Summary of M-03A Rev 11 Changes

SOS May 2016 Ronald DeLoach

Overview of M-03A Changes

Exhibit D2: Sample PJM Behind the Meter Generation Submission Form for Distribution, With Supporting One-Line Diagram

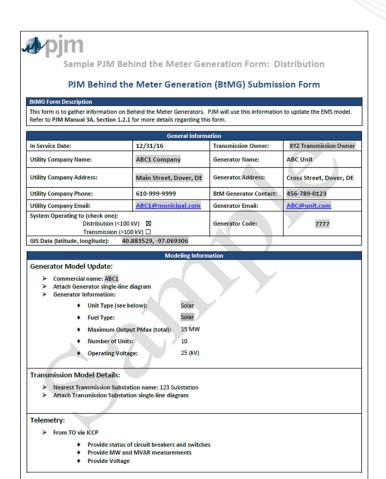
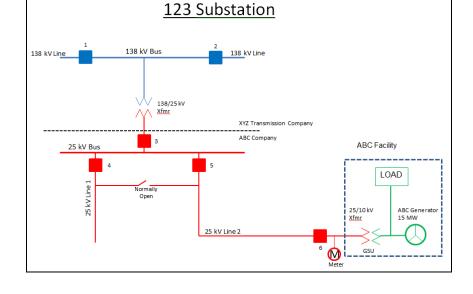
- Note: Detailed review of processes and procedures referenced in this appendix provided as part of a separate DMS agenda item
- Detailed explanation of field requirements in the new PJM Behind the Meter Generation Submission Form
- Example of form submission where unit tied to transmission facilities
- Example of form submission where unit tied to distribution facilities

Exhibit 3: Timeline for PJM Actions in Coordinating Model Update—Sample Summer Process

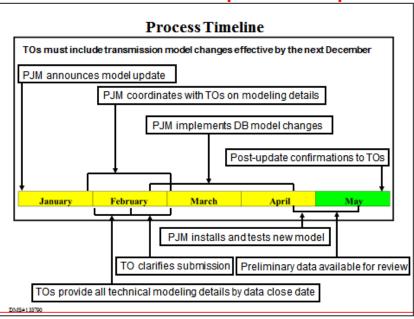
- Removed Exhibit 3: Timeline for PJM Actions in Coordinating Model Update - Sample Summer Process since info already covered in Exhibit 4: Network Model Data Submission & Model Validation Timeline
 - Repointed all references to removed exhibit to Network Model Data Submission & Model Validation Timeline exhibit
- Added task for model update testing period to Network Model Data
 Submission & Model Validation Timeline exhibit
- Adjusted effective model update area with colors to better explain period being modeled and time period to date of model build forward

Exhibit 43: Network Model Data Submission & Model Validation Timeline

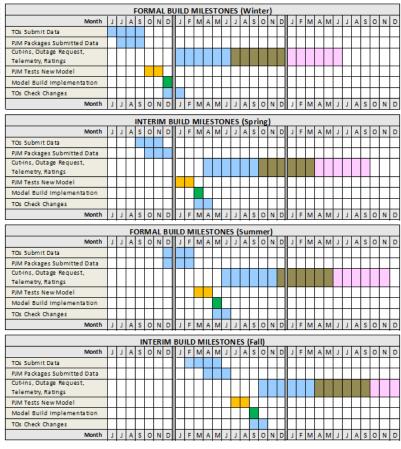
Updated renumbered Exhibit 3: General Schedule for Submitting Modeling Data by replacing Target In-Service Date for Project with Required & Preferred In-Service Date for Project columns to better align with updated Exhibit 4: Network Model Data Submission & Model Validation Timeline
